UNITED STATES PATENT AND TRADEMARK OFFICE

APPLICATION NO.	FILING DATE	FIRST NAMED INVENTOR	ATTORNEY DOCKET NO.	CONFIRMATION NO.
10/024,656	12/17/2001	Amir Belson	BEL1020U	2664
25197	7590	08/25/2004	EXAMINER	
LEARY & ASSOCIATES 3900 NEWPARK MALL RD. THIRD FLOOR, SUITE 317 NEWARK, CA 94560			QADERI, RUNA S	
			ART UNIT	PAPER NUMBER
			3737

Office Action Summary	Application No. 10/024,656	Applicant(s) BELSON ET AL.	
	Examiner Runa S. Qaderi	Art Unit 3737

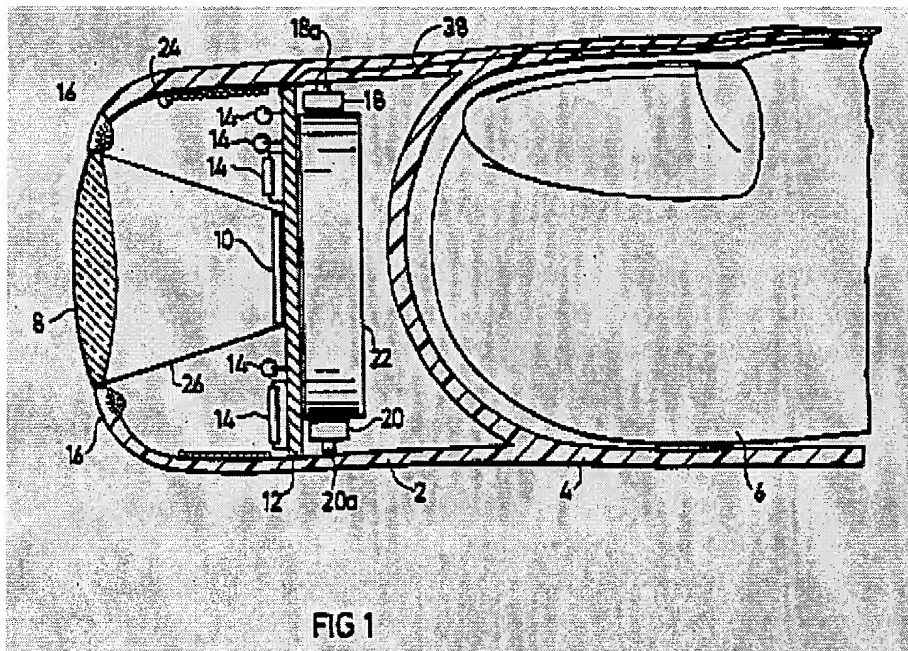
Oz discloses an optical viewing system for viewing areas to be examined which are difficult or extremely awkward to view. Figure 1 of Oz below diagrams the optical viewing system configured to be mounted on the user's hand, more preferably on the

user's finger. The optical viewing system comprises a light source (16) for illuminating the space in front of the focussing lens (8), an image sensor (10) for receiving the optic image focused onto the lens (8) and transforming the image into electrical signals. The image sensor is a CCD, commonly used in solid-state television cameras. A remote unit (figure 2) includes a unit (46) for displaying the image sensed by the CCD image sensor (10). Figures 1 (below) and 6a, 6b, and 6c of Oz satisfy the applicant's limitation to tapered distal and proximal end for ease of insertion. The teaching to mounting on the finger of the user satisfies the applicant's limitation to mounted on a ring because a ring is interpreted as configured to be mounted on a finger.
